From: Bob/Chris Berndt [mailto:bberndt500@aol.com]
Sent: Wednesday, May 23, 2018 12:12 PM
To: Jeanette Coffin <jcoffin@townofchapelhill.org>
Subject: FW: Eastowne SUP --May 23, 2018 Council Meeting Comment--Agenda Item #16

From: Bob/Chris Berndt [mailto:bberndt500@aol.com]
Sent: Wednesday, May 23, 2018 12:06 PM
To: 'mayorandcouncil@townofchapelhill.org'
Cc: 'Kay Pearlstein'; 'Judy Johnson'; 'amymorrisryan@gmail.com'; 'Ben Hitchings'
Subject: Eastowne SUP --May 23, 2018 Council Meeting Comment--Agenda Item #16

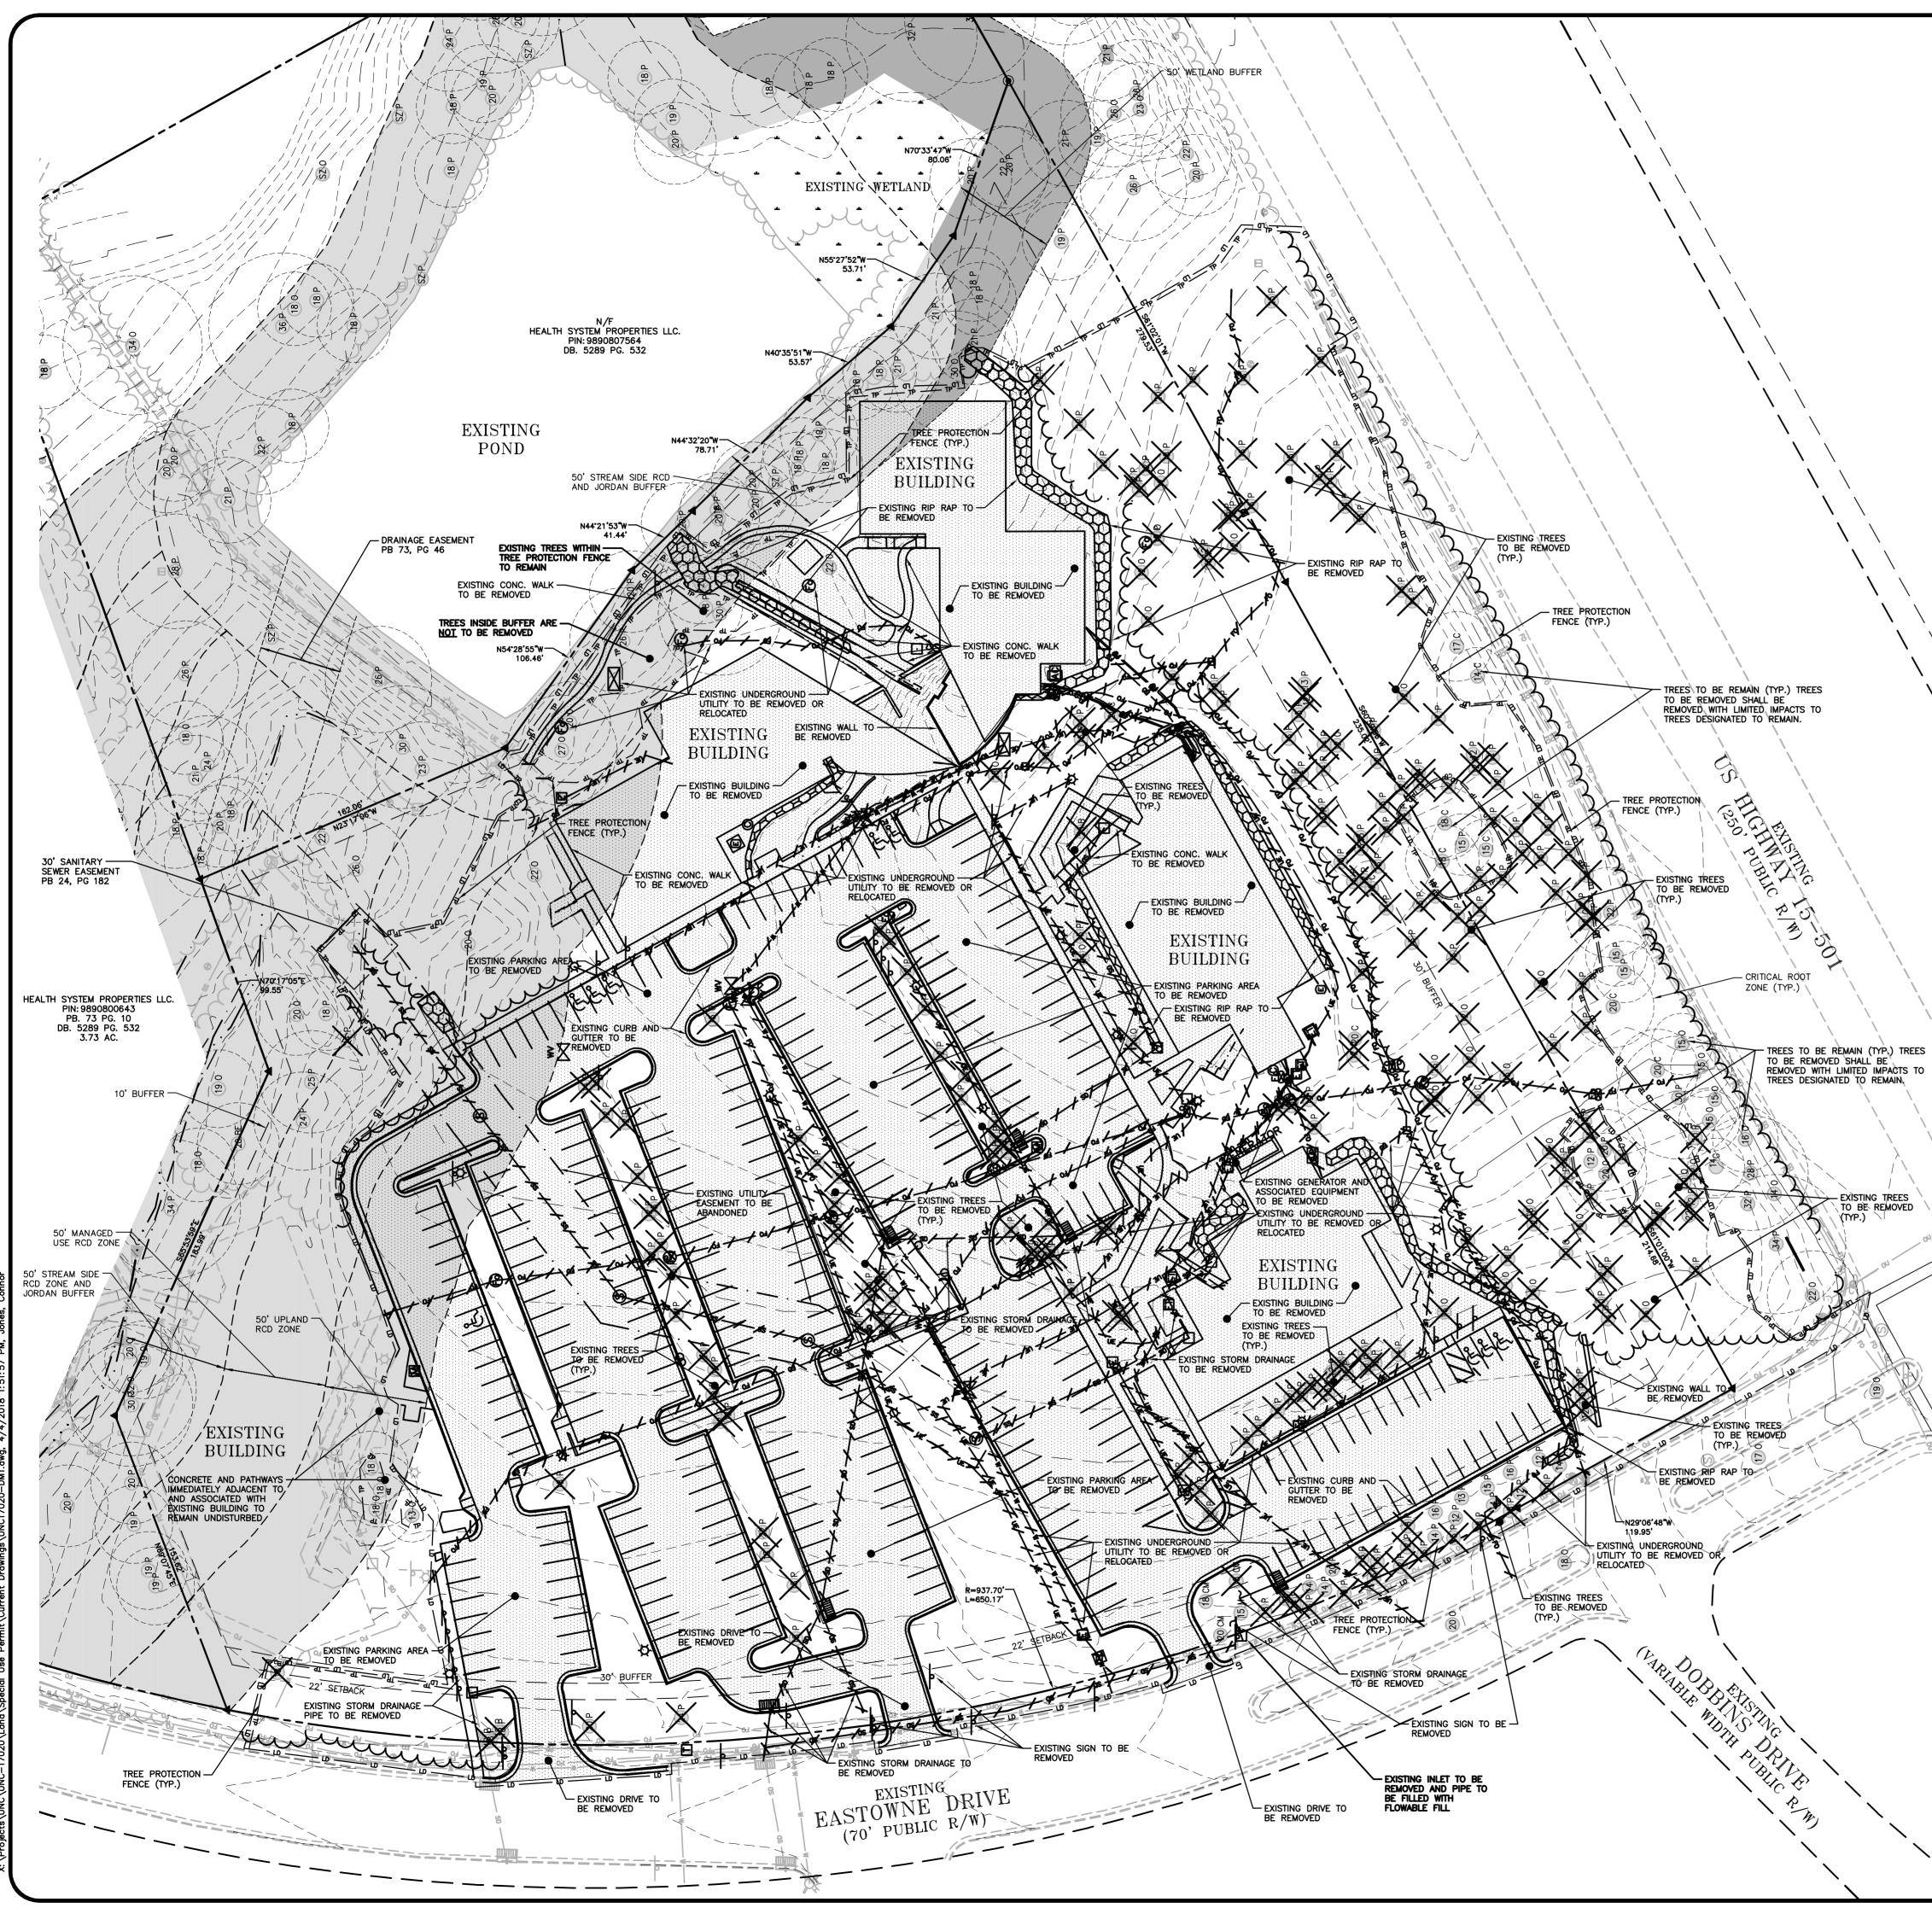
I am writing to ask that the Council not authorize the removal of the existing forested buffer along the Town's major entranceway, 15-501, at Eastowne. The current proposal would remove all of the existing trees in the existing buffer on the applicant's property. I believe the existing buffer is 70 feet, whereas the proposed buffer is only 30 feet. In addition, the proposal removes most of the trees in the NCDOT right of way. Please see the attached plan C-3 from the applicants materials.

The forested buffer is an important aspect of the visual beauty of this entranceway, and is an existing community asset that should be preserved. Our tree-lined major transportation corridors are a key component of Chapel Hill's natural and historic character.

While 26 trees are to be retained, and new landscaping is to be installed to enhance visibility, the result will be a completely different landscape and visual feel than that which exists now. The Planning Commission asked that additional canopy trees be provided on the front buffer, and the staff report says this recommendation is incorporated into the stipulations. However, I do not see how the Planning Commission recommendation is included. At a minimum, please make sure that a significant number of canopy trees are provided in the buffer and in the right of way.

The Community Design Commission voted 3-2 to recommend the project with conditions. The materials do not explain our vote, so I wanted to have the opportunity to express why I did not recommend to you this particular site plan. I am not against the project or the use in this location, but I believe the applicant could design the development in a way that saves the forested buffer.
